ADDENDUM # 1

BID NO. B2013-37

Bid for El Retiro and Southeast Library Accessibility Upgrades

ADDENDUM # 1- Issued 7-11-13

typical handrail elevation

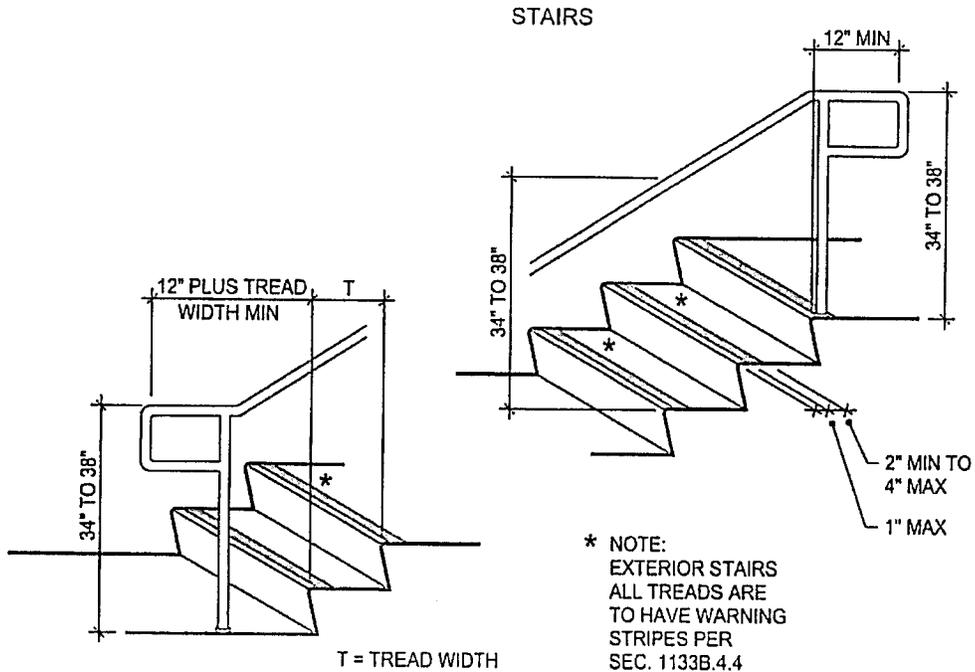
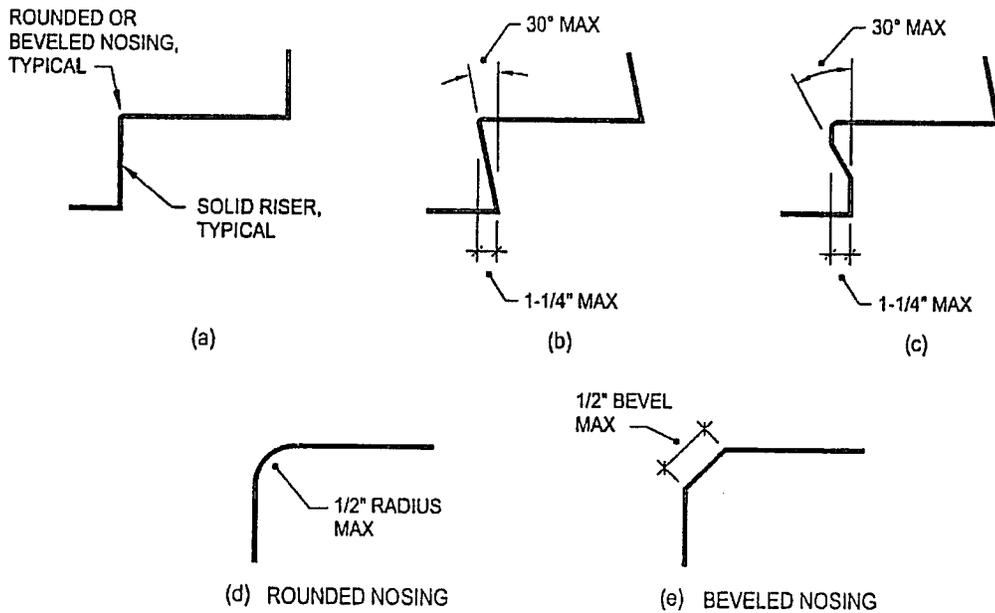
2. ATTACHED: The plans indicate that the existing entry stair handrails are to remain. Please include a cost in your bid to replace these with new 1-1/2" diameter pipe rails, with extensions similar to the attached details (2 pages). Also provide a center intermediate handrail.
